Detailed Site Plan Library Apartments

DSP-01002-04

STAFF REPORT

SUBJECT: Detailed Site Plan DSP-01002-04
Type 2 Tree Conservation Plan TCP2-050-2023
Library Apartments

Figure 1: Site Plan

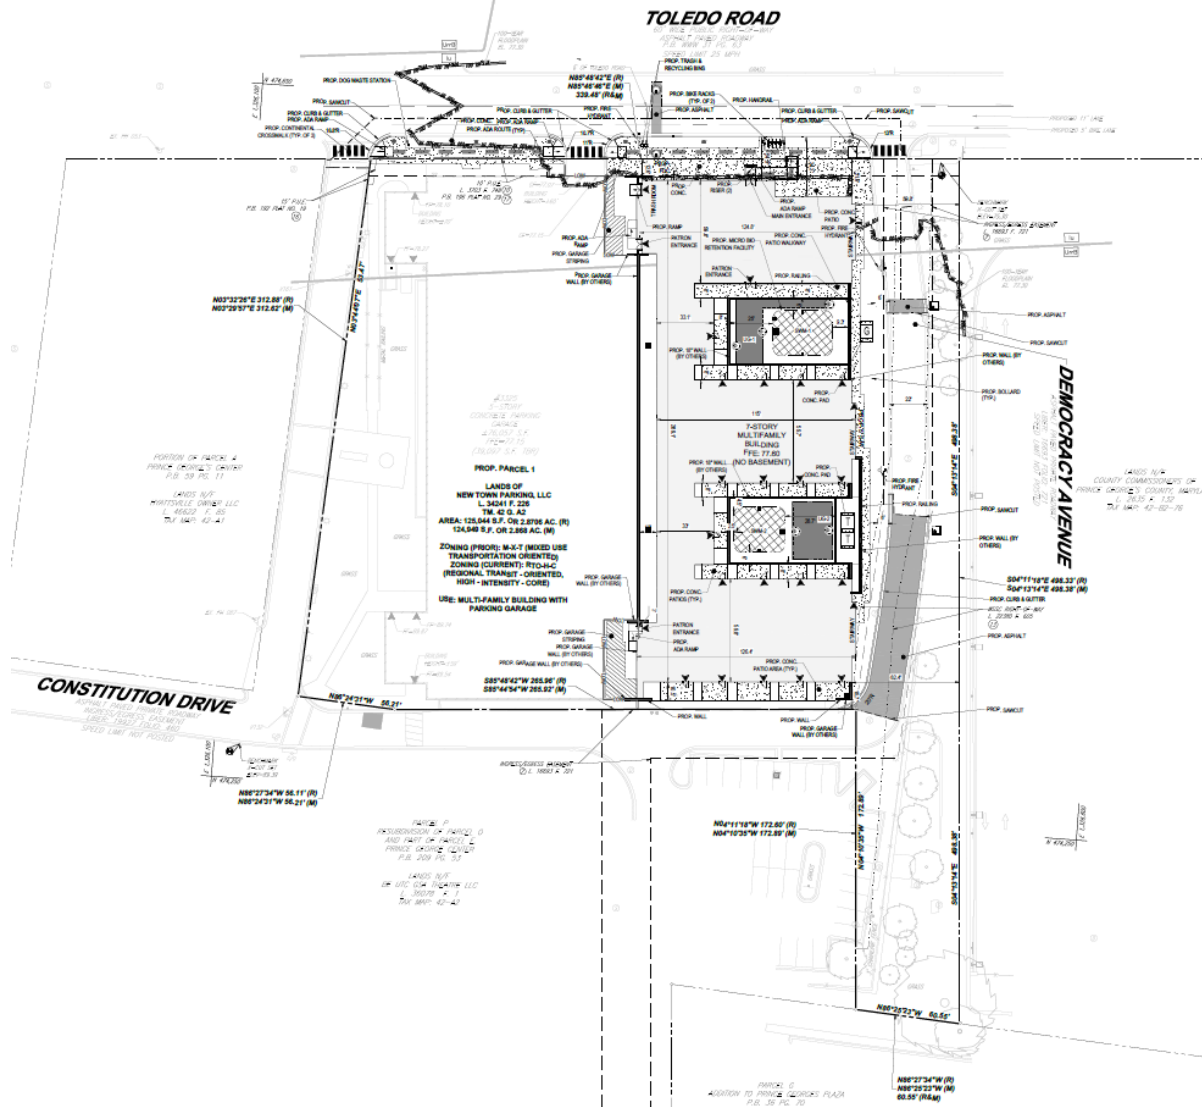
Improved sidewalks around the proposed multifamily building are shown along Toledo Road and Democracy Avenue. Three crosswalks are shown on the plan. One crosses the drive aisle at the entry/exit point of the remaining portion of Garage A on Toledo Road. The other two cross Democracy Avenue and a private roadway to the west of the garage, respectively. These crosswalks connect gaps in the sidewalk network of the area while bringing attention to motorists that pedestrians may be crossing. The Americans with Disabilities Act (ADA) ramps are also incorporated to enhance connectivity. Because the proposed development is through the repurposing of Garage A, the existing retaining walls not only dictate the footprint and placement of the building but also make the construction of a sidewalk along Constitution Drive impossible. If future residents would like to walk to the Hyattsville Crossing (formerly known as Prince George's Plaza) Metro Station and the Mall at Prince George's Plaza, located to the south of the development, they will first use the walkway located to the west of Garage A and cross Constitution Drive to access the sidewalk

Figure 6: Floor Plan of the Recreational Facilities

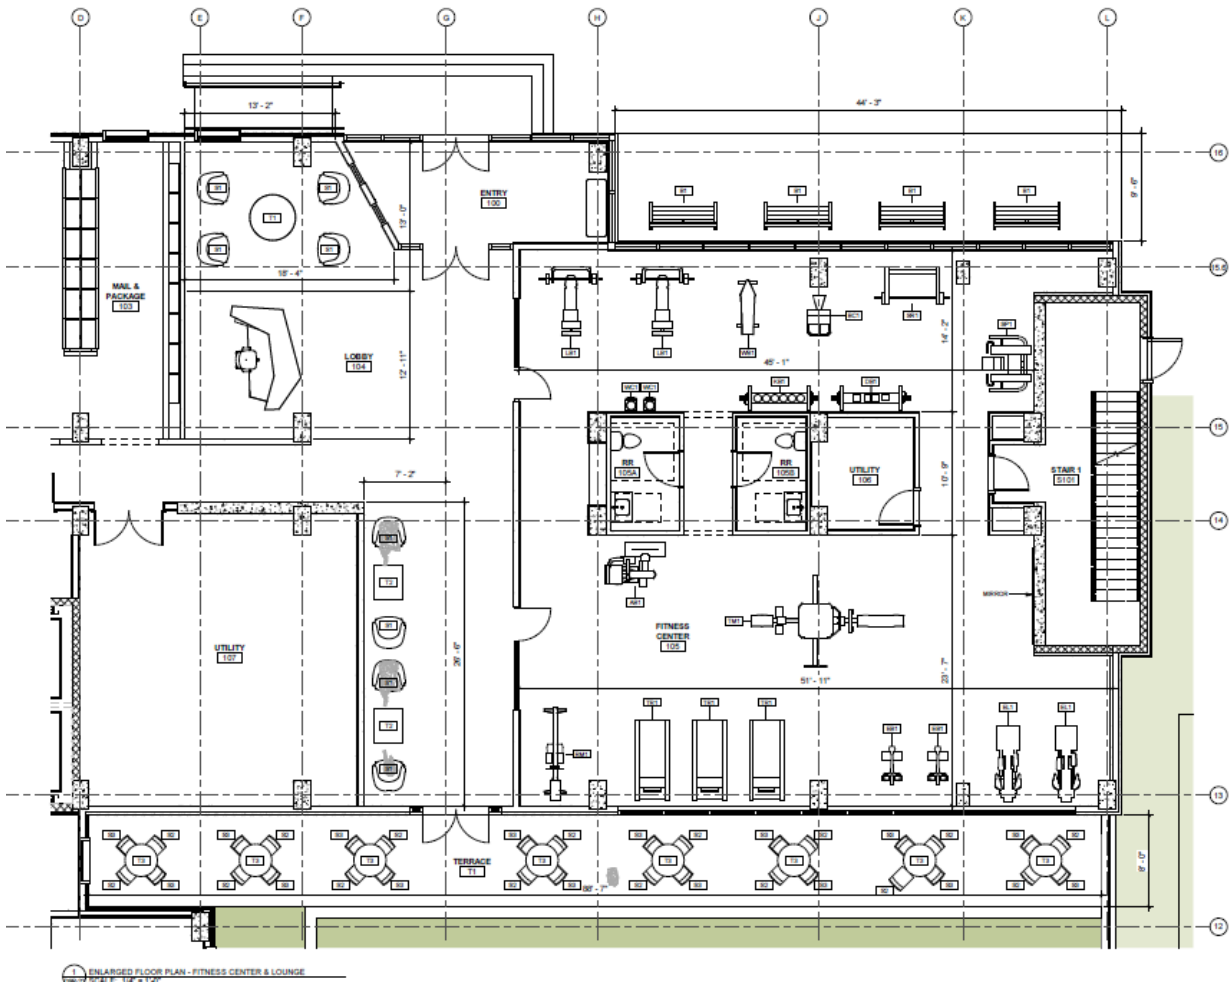
Inside the fitness center, the applicant provides various amenities. The submitted plans also show that there is a discrepancy between the Recreational Facilities Calculation Table on the coversheet and the recreation furniture list on Sheet DSP-22. A condition has been added to ensure information between the calculation table and furniture list is consistent. No bike rooms or courtyard pools are included in this DSP, which is stated in Note 14 in General Notes. A condition is included to update information associated with this note. In addition, this development includes a linear space for a dog run between the proposed building and Garage A. The wall around the dog run is concrete masonry unit blocks and double-paned windows will be used for the openings, all of which prevent sound transfer. A condition is included herein requiring the applicant to provide a dog drinking fountain in the proposed dog run area.

Finally, the applicant also provides street amenities, along Toledo Road, including a dog waste station, bike racks and trash and recycling bins, with details. Conditions are included herein requiring the applicant to provide one dog station, and trash and recycling bins along Democracy Avenue. Additional seating is necessary on both Toledo Road and Democracy Avenue.
